Mods(marked in green):

Finished View - Side

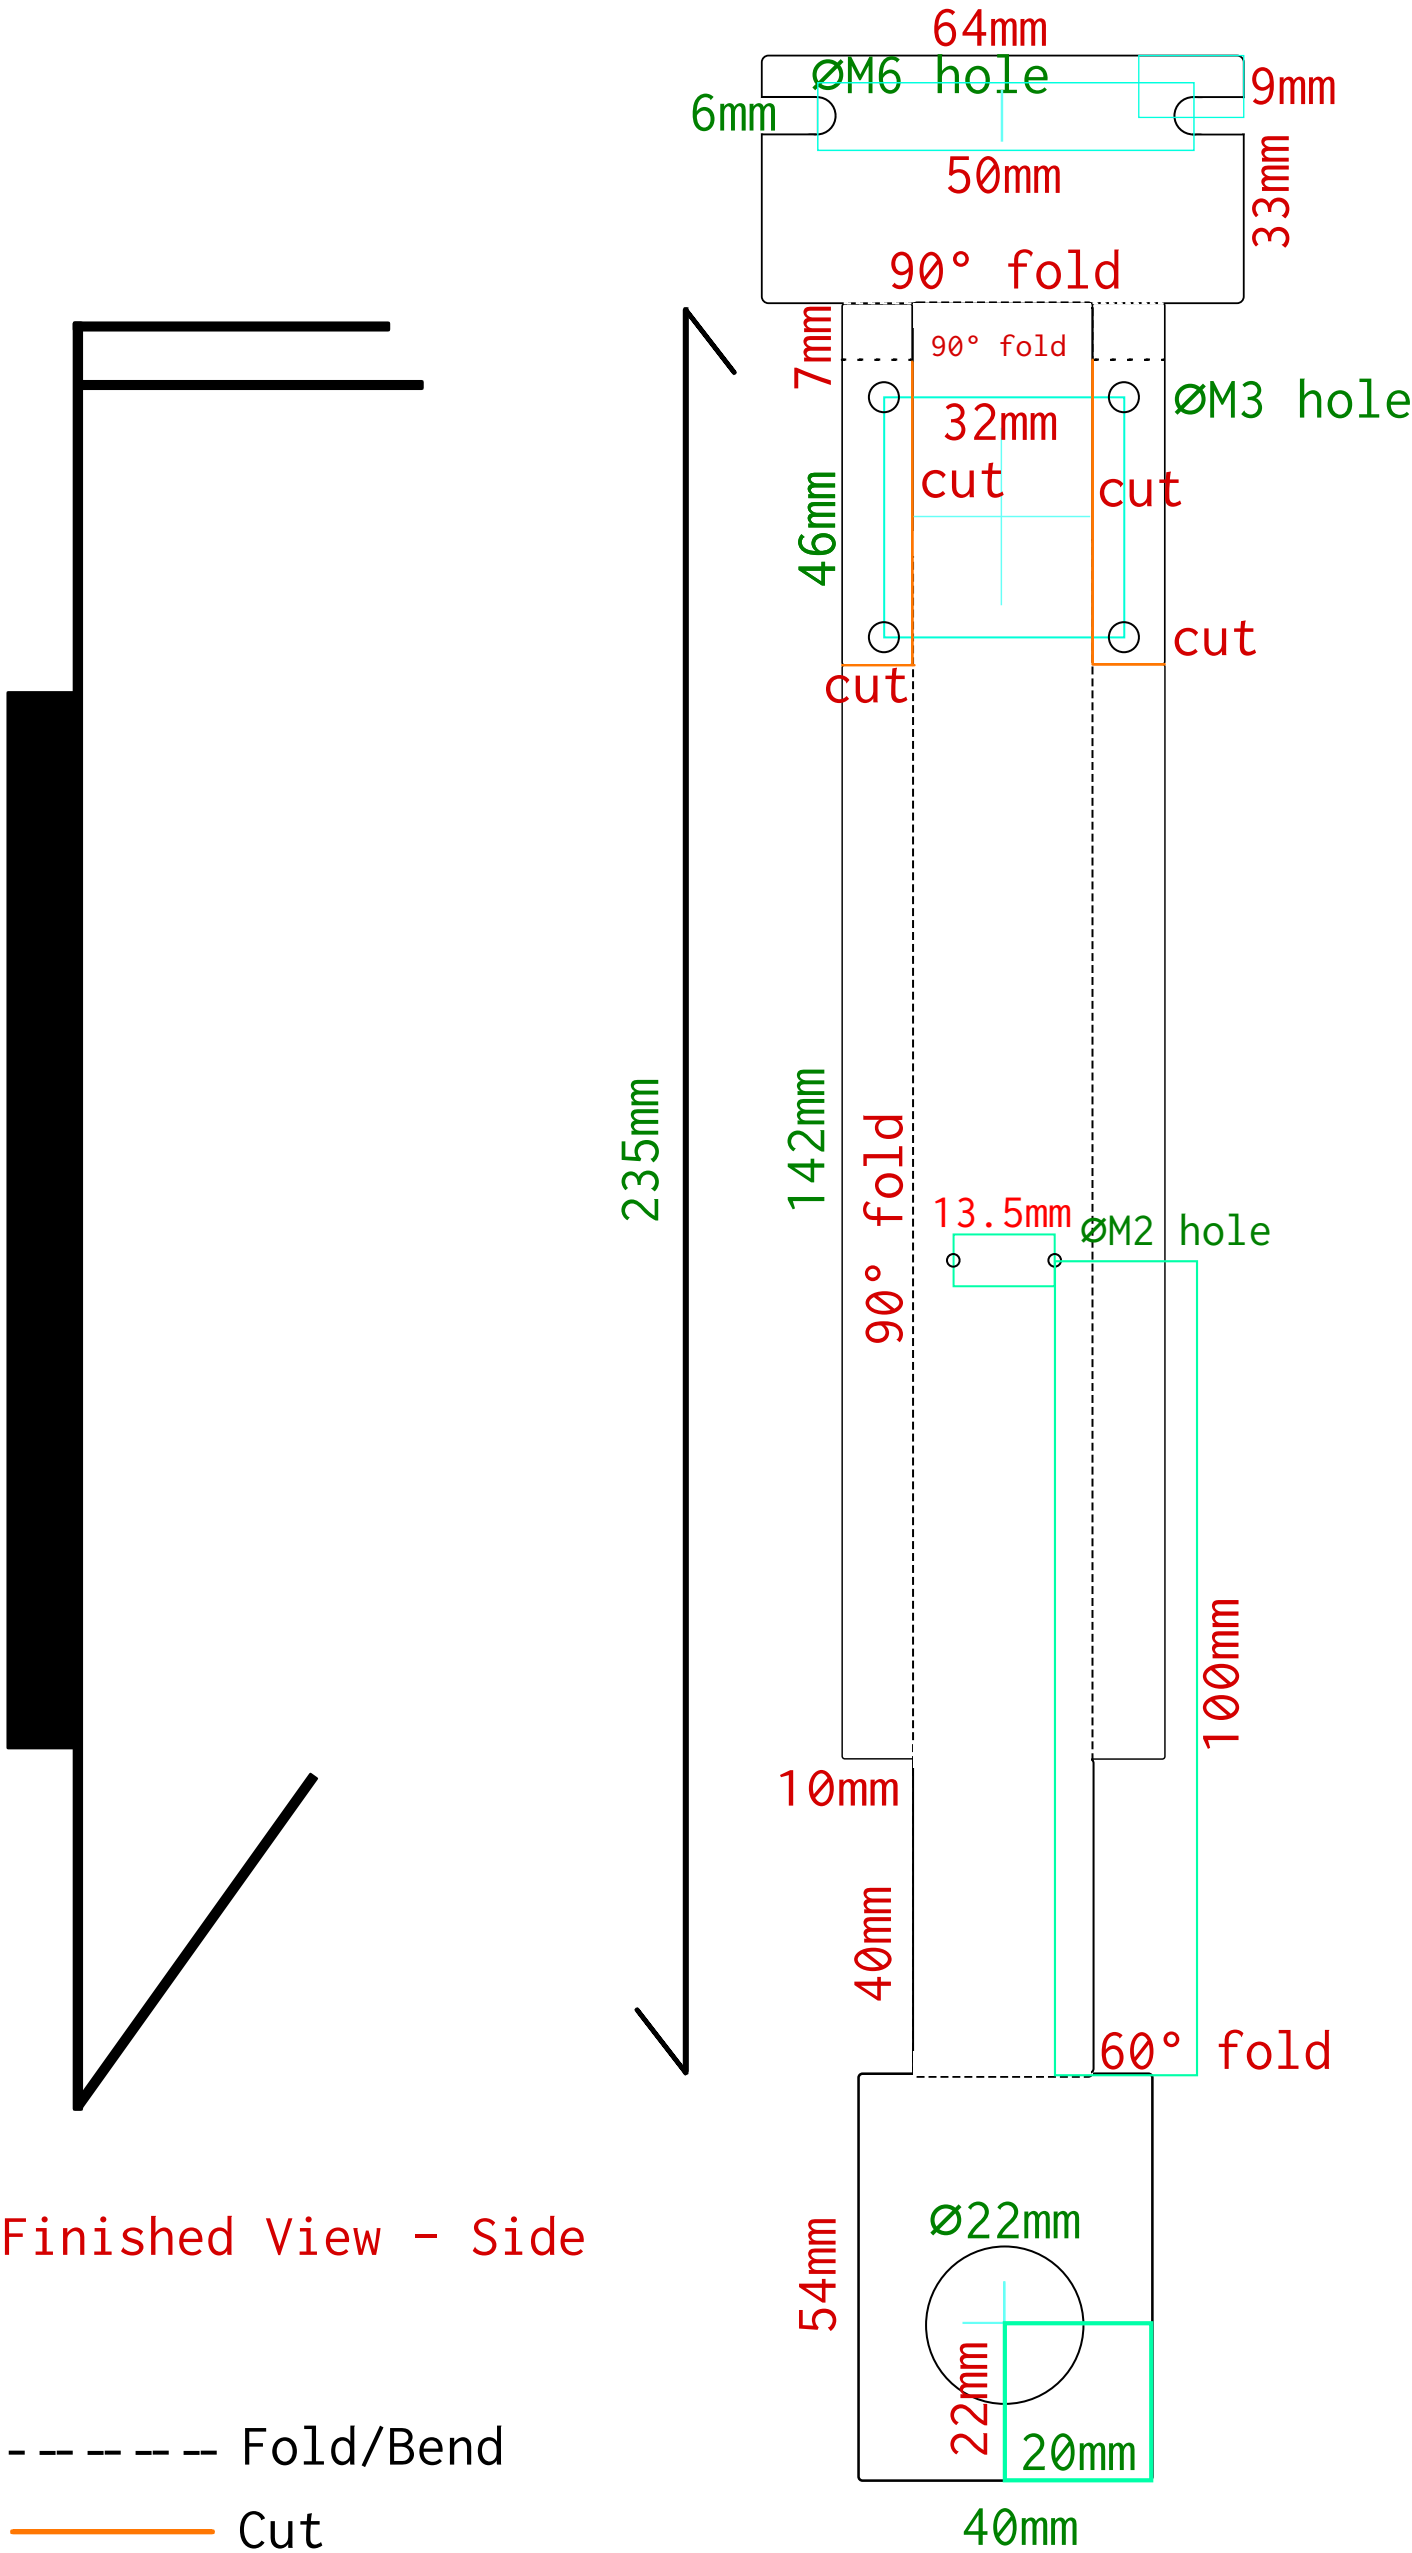
- 1. Updated hole sizes, all holes are clearance holes.
- 2. Instead of holes on the top, we are going with M6 holes with channels cut to the edge.
- 3. The length of the 2 wings has been extended by a few mm (42 --> 46 mm).
- 4. The bottom foling portion has been made wider (40mm) to accomodate a larger circular hole.
- 5. The length of the long folding flaps (142 mm) dooes not have to be accurate, so cuts can be placed such that its size is reduced.
